**TOWN OF MOUNTAIN VILLAGE
DESIGN REVIEW BOARD REGULAR MEETING
THURSDAY MARCH 2, 2017 10:00 AM
2nd FLOOR CONFERENCE ROOM, MOUNTAIN VILLAGE TOWN HALL
455 MOUNTAIN VILLAGE BLVD, MOUNTAIN VILLAGE, COLORADO
AGENDA**

**SUMMARY OF MOTIONS
TOWN OF MOUNTAIN VILLAGE
DESIGN REVIEW BOARD MEETING
THURSDAY, FEBRUARY 2, 2017**

1 Site Plan- Landscape
 1/8" = 1'-0"

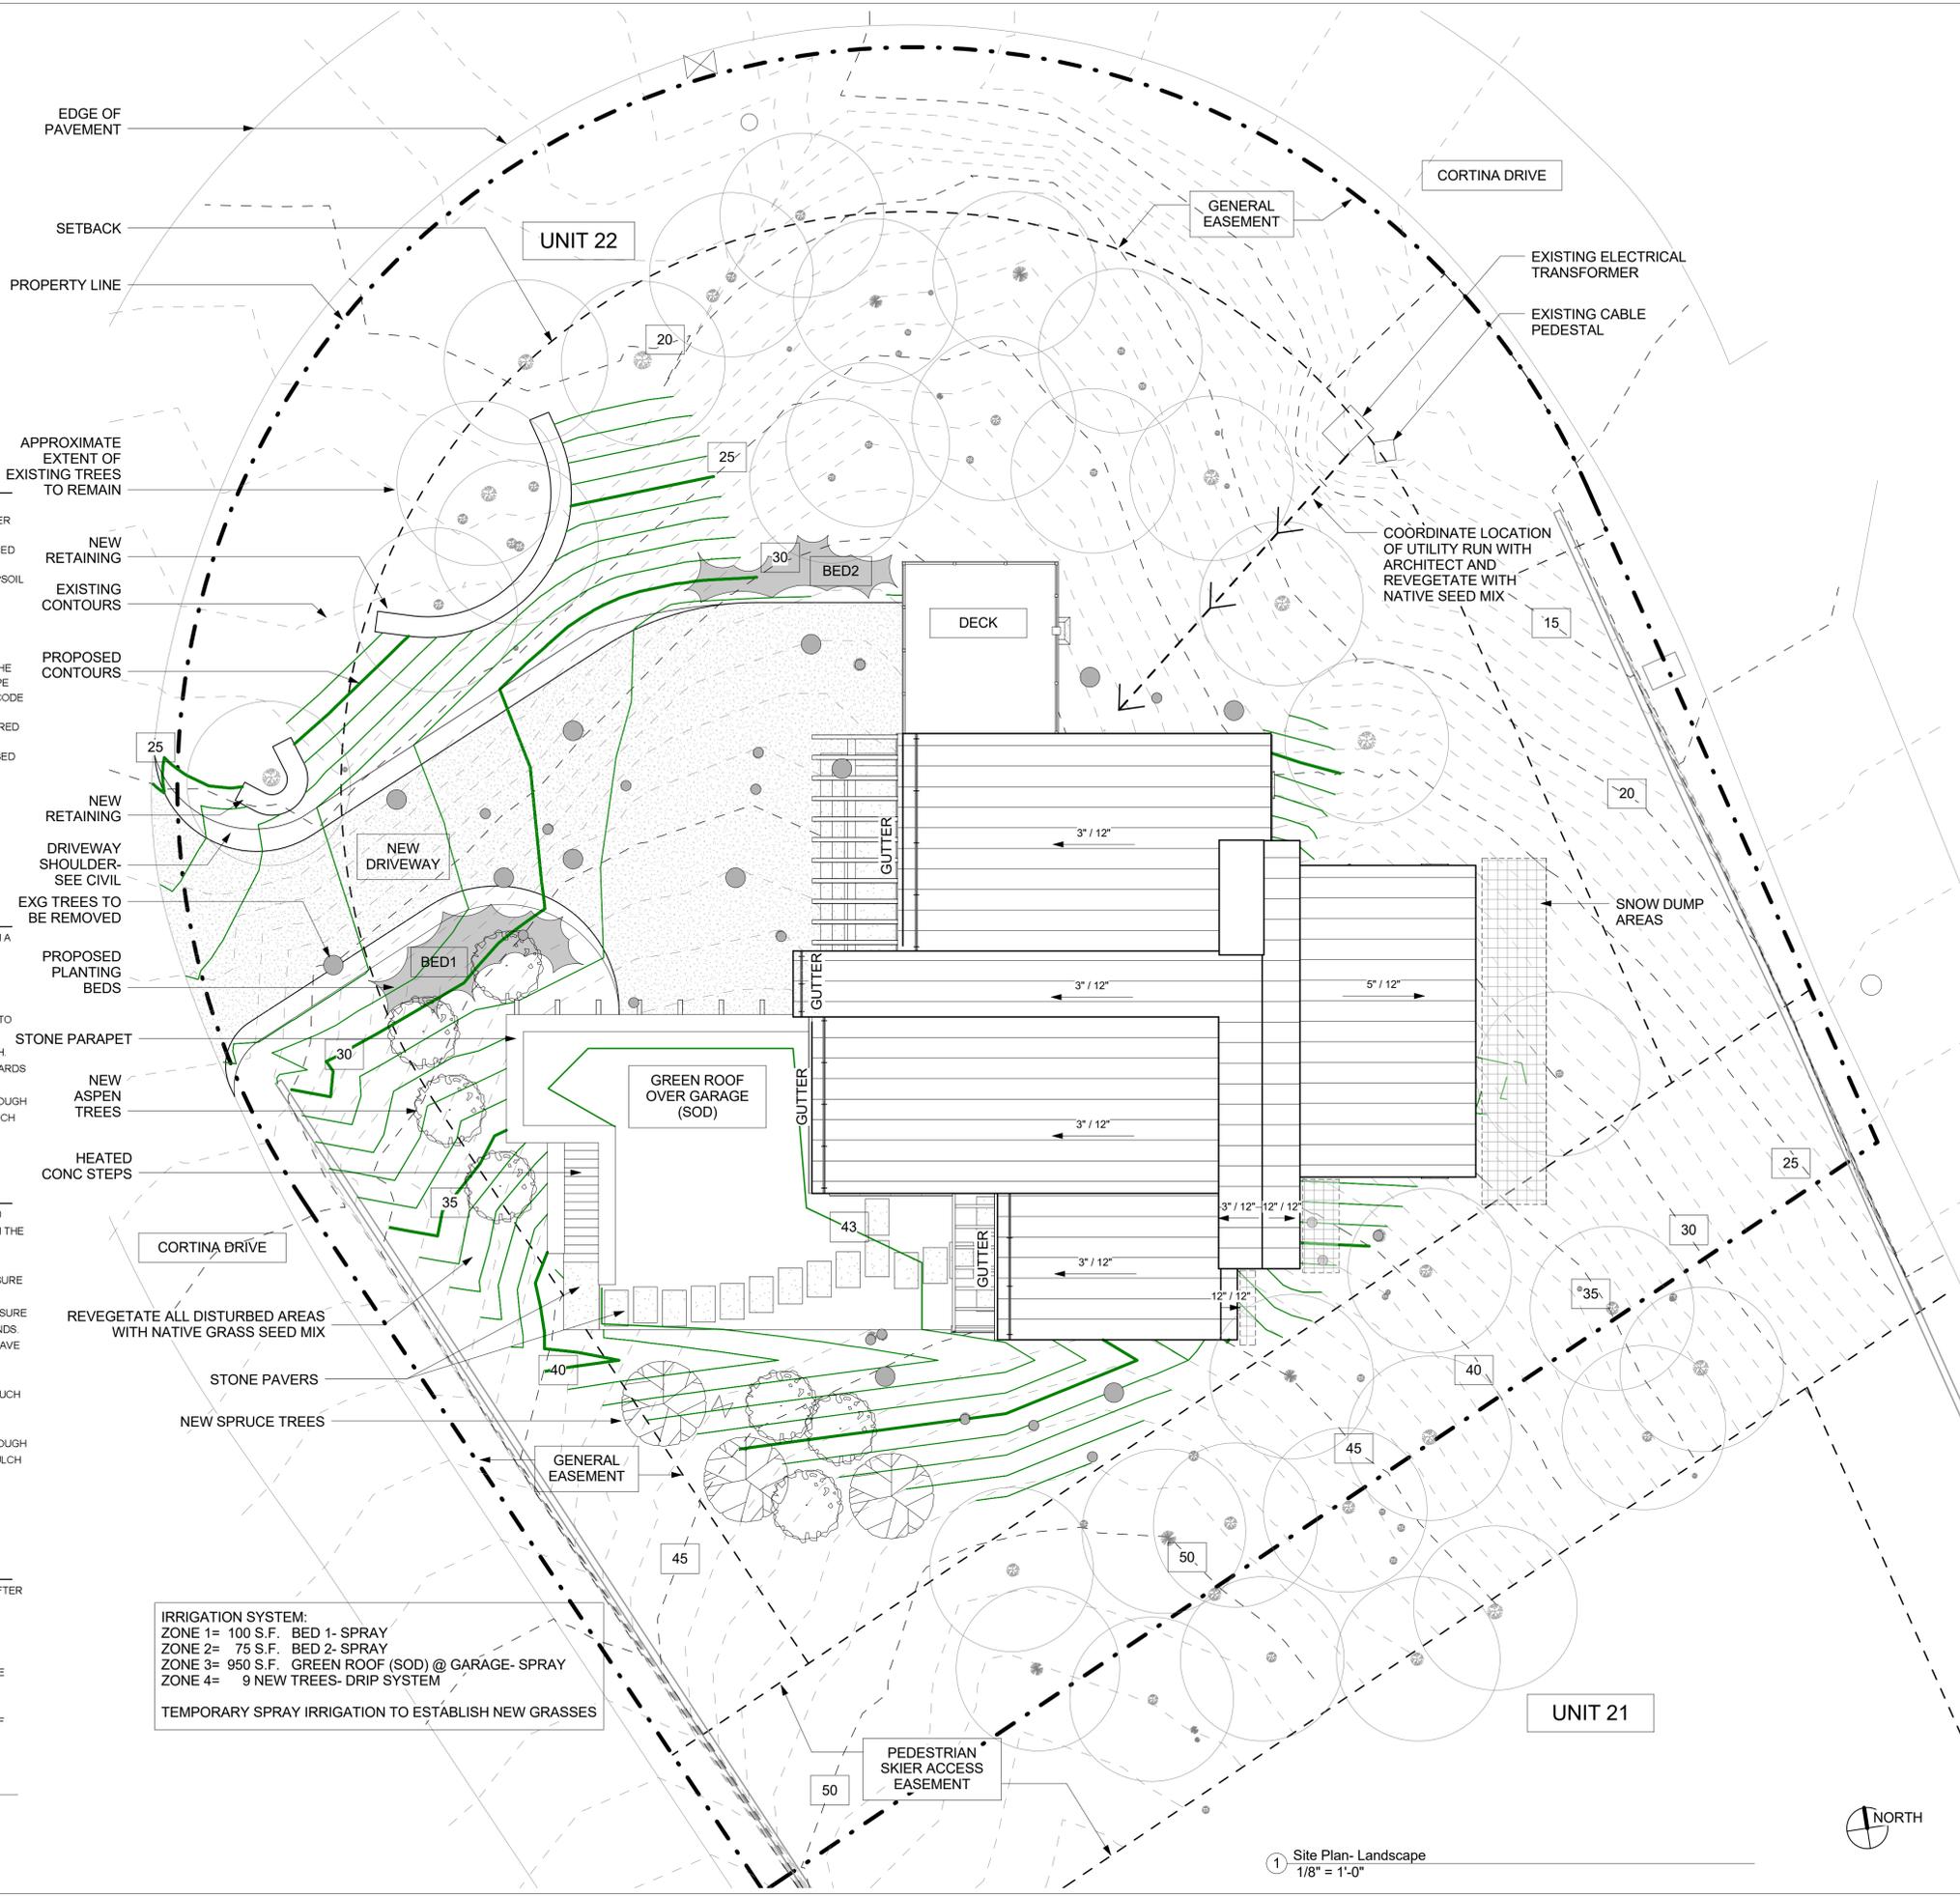
In addition to the existing vegetation, the proposed landscape plan shows an addition of 3 Dwarf Colorado Spruce and 7 Quaking Aspen, as well as 2 gardening beds. All plantings will need to be in compliance with Table 5-4 of the CDC:

① 09 Roof Plan- Height Calculations
1/4" = 1'-0"

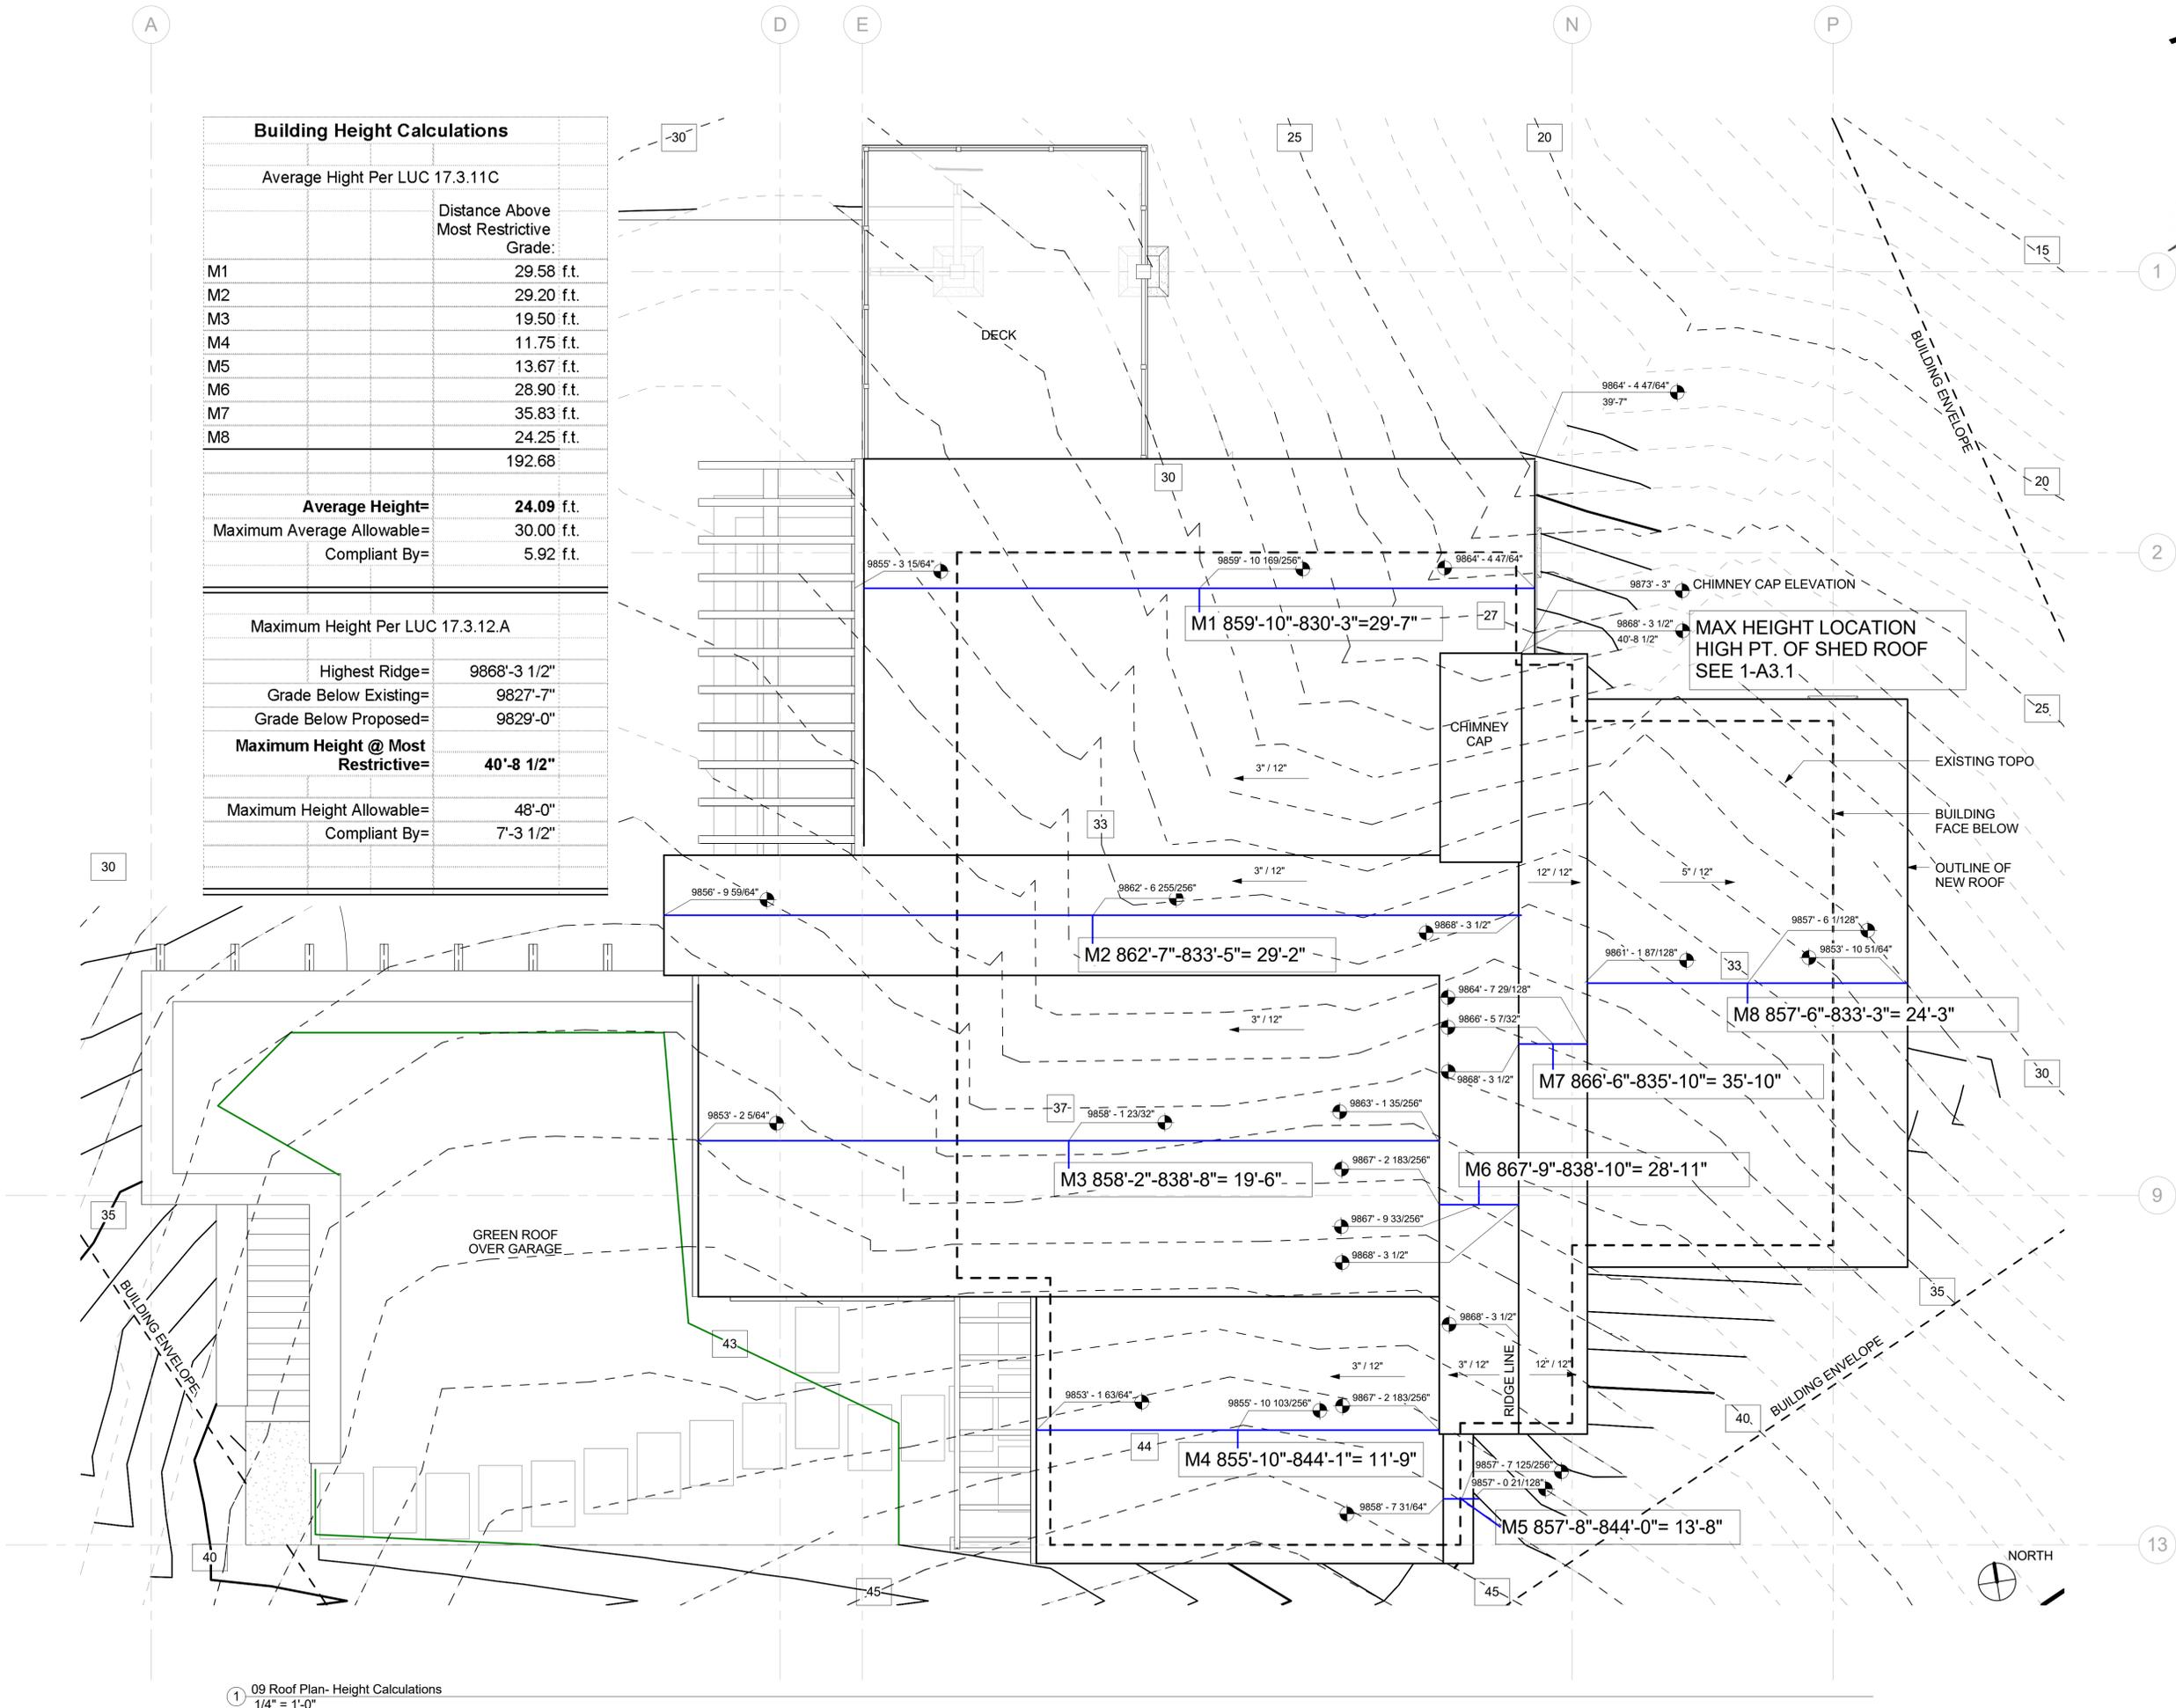
The CDC allows for primary roof pitches to be between 6:12 and 12:12 and be gable in form, and secondary roofs will not have pitches less than 4:12 and be either gable or shed in form. The proposed roof forms are a combination of a primary "asymmetrical gable" and 4 sheds. The primary asymmetrical gable has a 3:12 and 12:12 pitch, and the secondary shed roofs have 3:12 pitches. Each demonstrates sloped planes, and varied ridgelines pursuant to current and pending development codes. Nevertheless, variations will be needed to allow primary roof forms under 6:12, and secondary roof pitches under 4:12.

1. A survey of the footers will be provided prior to pouring concrete to determine that there are no encroachments into the GE.
2. A ridge height survey will be provided during the framing inspection to determine the building height is in compliance.
3. The residence shall have a monitored fire sprinkler system; and the numbers on the address monument shall be coated or outlined with material to cause them to be reflective.
4. Prior to the issuance of a building permit, the applicant shall field verify all utilities and submit a revised utility plan to the public works director identifying the location of utilities and connection points.
